**RE: THE VILLAS @ CANANDAIGUA – SECTION 4**  
**FINAL SUBDIVISION AND SITE PLAN REVIEW**  
**TAX MAP NO. 97.08-2-200.130**  
**CPN-006-18**  
**MRB PROJECT NO.: 0300.12001.000 – PHASE 128**

MRB has completed a review of the submitted Final Subdivision Plat and Final Site Plan dated January 2018, prepared by BME Associates. We offer the following comments for the Town's consideration. A brief written response to each of the following comments should be provided by the design engineer.

## TYPICAL WATER SERVICE

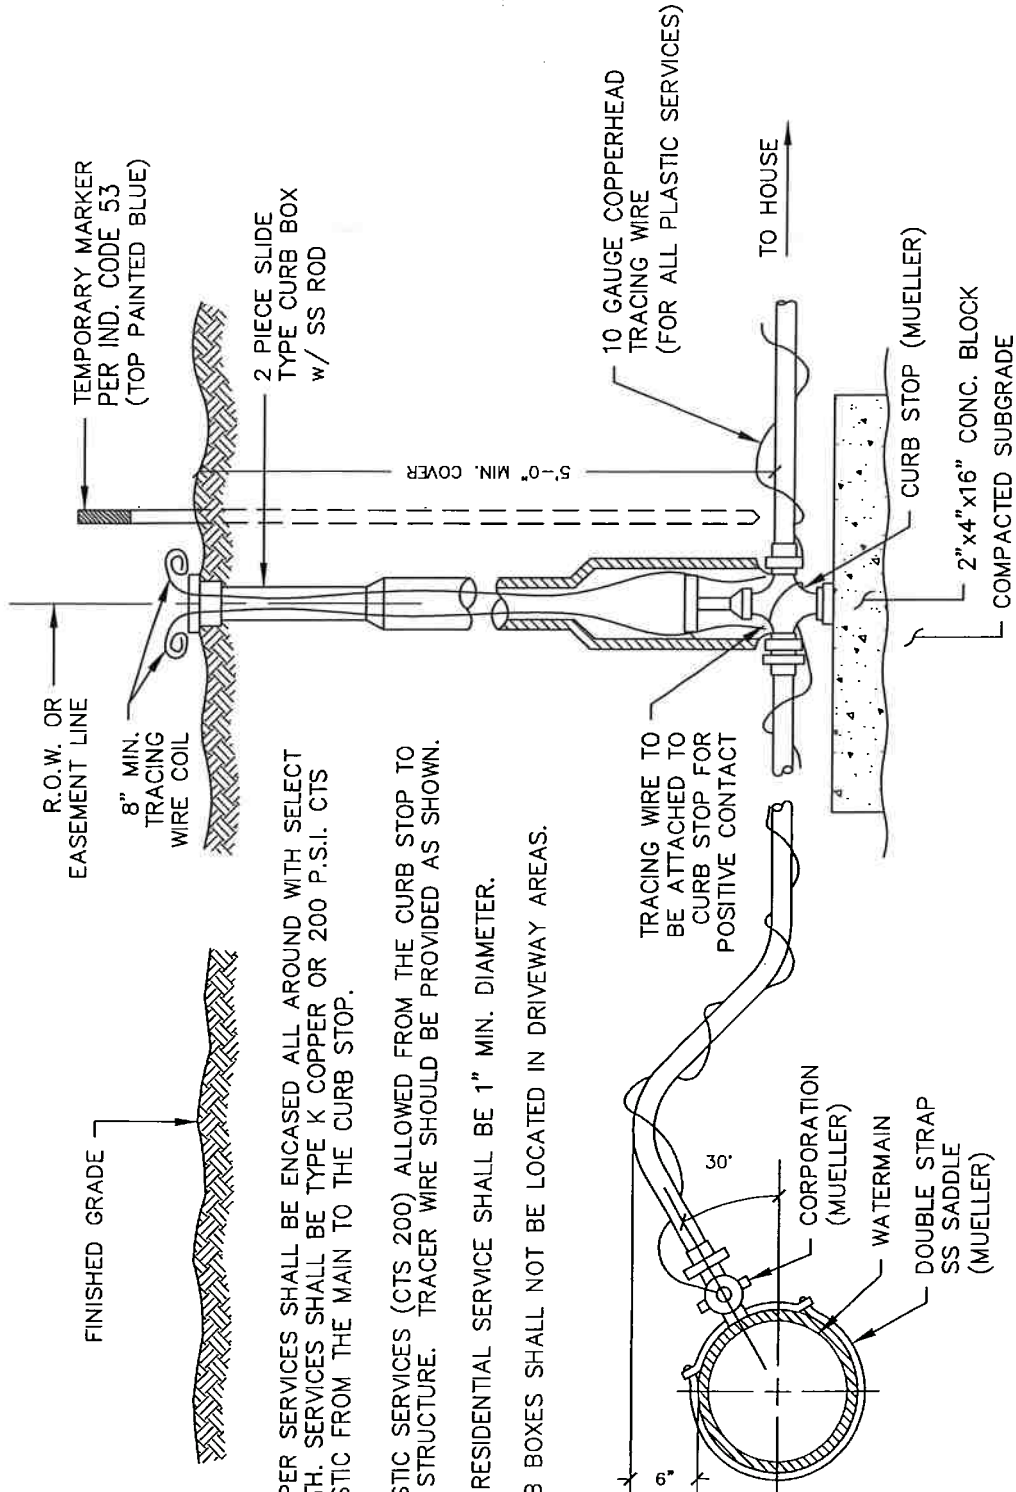
17. The MRB Group logo should not appear on the details.
18. The following details are to be updated on the plans:
  - Typical Water Service
  - Pipe Bedding/ Trench Detail
